**Planning Department
Transportation Development Services**

Re: 4th & Montano Dental Office
5508 4th St., NW
Traffic Circulation Layout
Engineer's/Architect's Stamp dated 6-2-15 (F14-D055)

Based upon the information provided in your submittal received 6-2-15, the above referenced plan cannot be approved for Building Permit until the following comments are addressed:

ENGINEER'S SEAL 4TH ST AND MONTANO DENTAL OFFICE	DRAWN BY DY
	TRAFFIC CIRCULATION LAYOUT	DATE 5/22/15
TIERRA WEST, LLC 5571 MIDWAY PARK PLACE NE ALBUQUERQUE, NM 87109 (505) 858-3100 www.tierrowestllc.com		2014099-TCL
RONALD R. BOHANNAN P.E. #7868		SHEET # C1
		JOB # 2014099

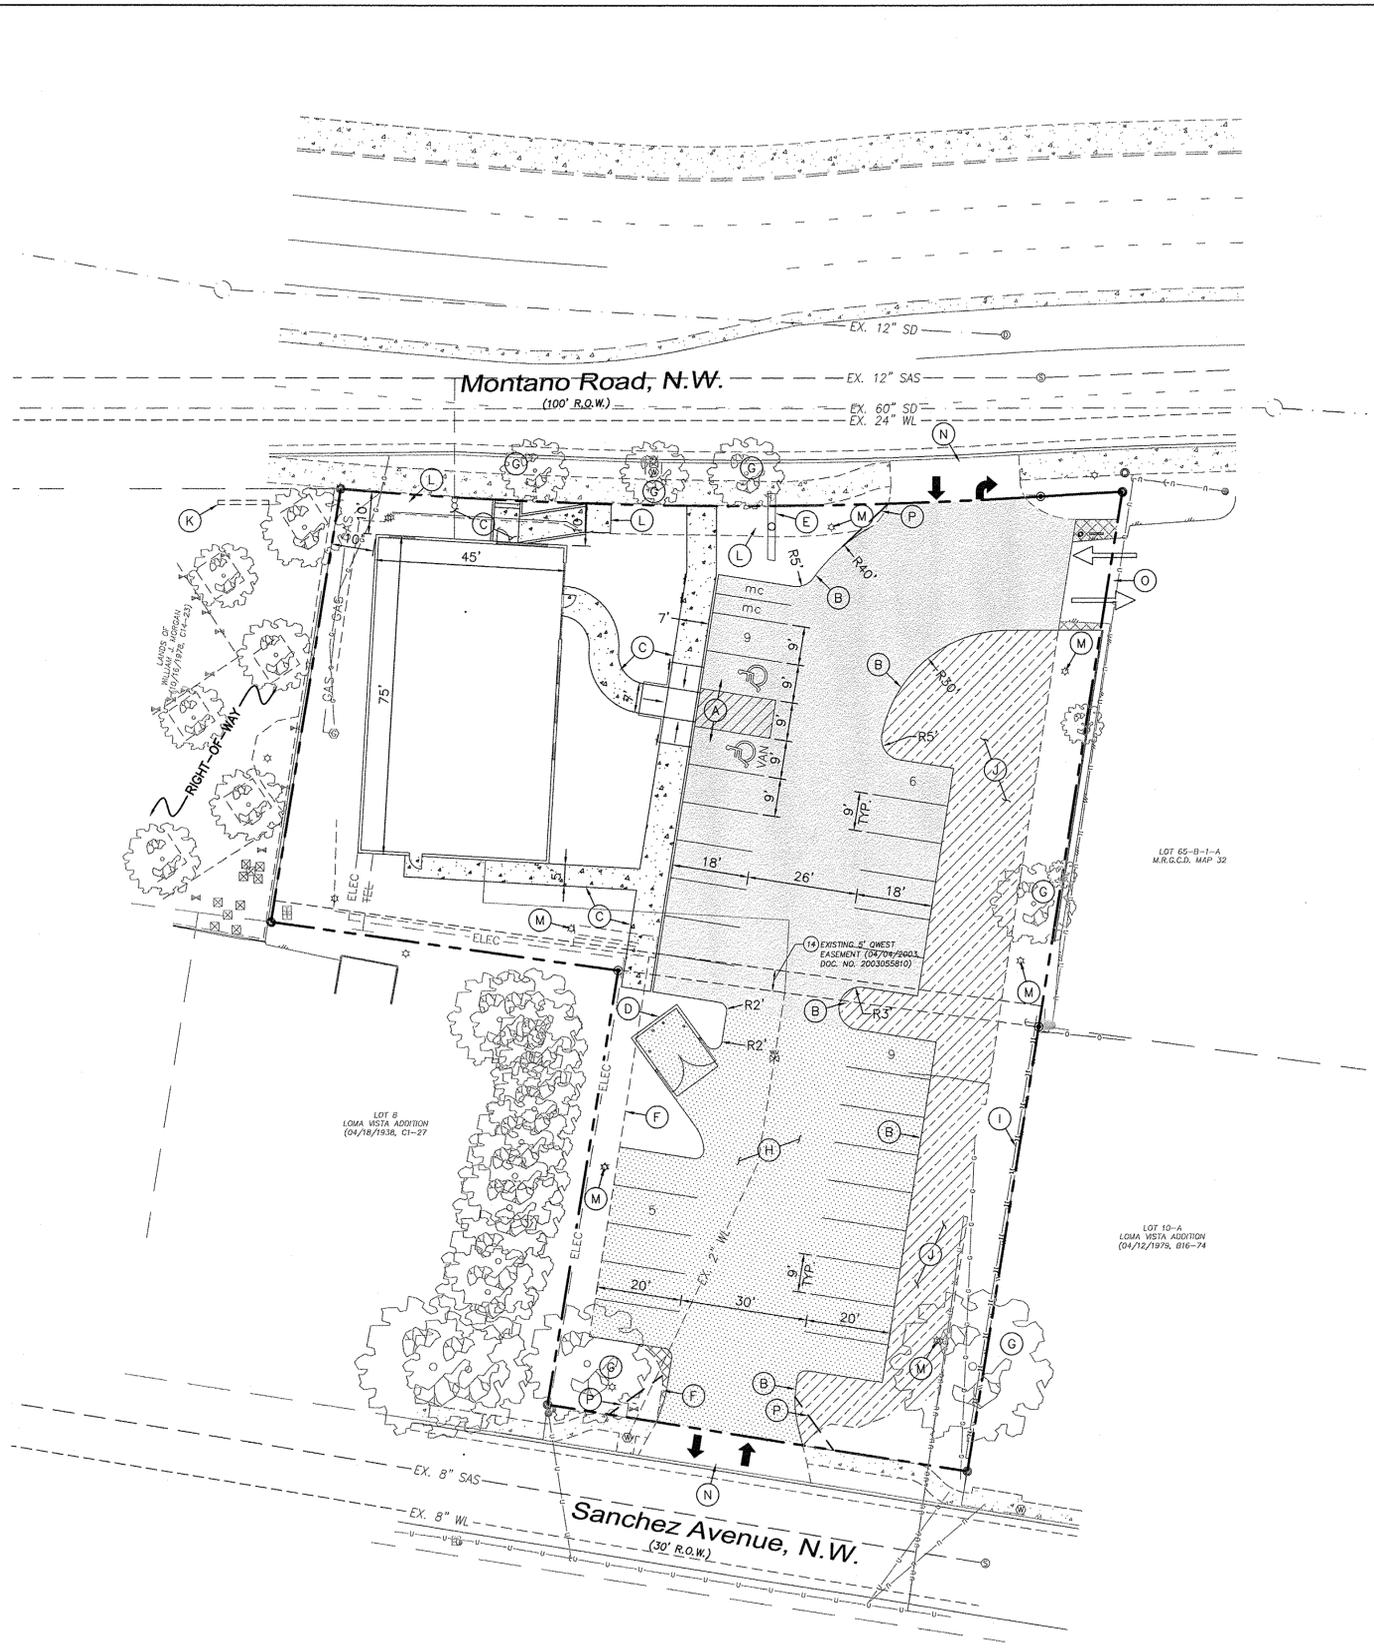
1. Clarify the extents of the current phase.
2. Identify all existing access easements and rights of way with dimensions.
3. Identify and dimension the existing right of way width, medians, sidewalks and curb cuts on Montano Rd., Sanchez Ave. and into the parcel to the east of the proposed building.

4. Please show a detail with dimensions and slope of the ADA pedestrian walkway transition from the ADA parking spaces.
5. The ADA van accessible sign must have the required language per 66-7-352.4C NMSA 1978 **"Violators Are Subject to a Fine and/or Towing."** Please show a detail of this signage.

6. The ADA access aisle shall have the words **"NO PARKING"** in capital letters, each of which shall be at least one foot high and at least two inches wide, placed at the rear of the parking space so as to be close to where an adjacent vehicle's rear tire would be placed. (66-1-4.1.B NMSA 1978)

7. Show all drive aisle widths and radii.
8. Design delivery vehicle route needs to be shown.
9. Please provide a sight distance exhibit (see the *Development Process Manual, Chapter 23, Section 3, Part D.5 Intersection Sight Distance*). Please provide this detail at the Montano Rd. and Sanchez Ave. entrances.

10. Please add the following note to the clear sight triangle: "Landscaping and signage will not interfere with clear sight requirements. Therefore, signs, walls, trees, and shrubbery between 3 and 8 feet tall (as measured from the gutter pan) will not be acceptable in this area."
11. Please include a copy of your shared access agreement with the adjacent property owner to the east of the proposed building.
12. Work within the public right of way requires a work order with DRC approved plans.
13. Please include two copies of the traffic circulation layout at the next submittal.
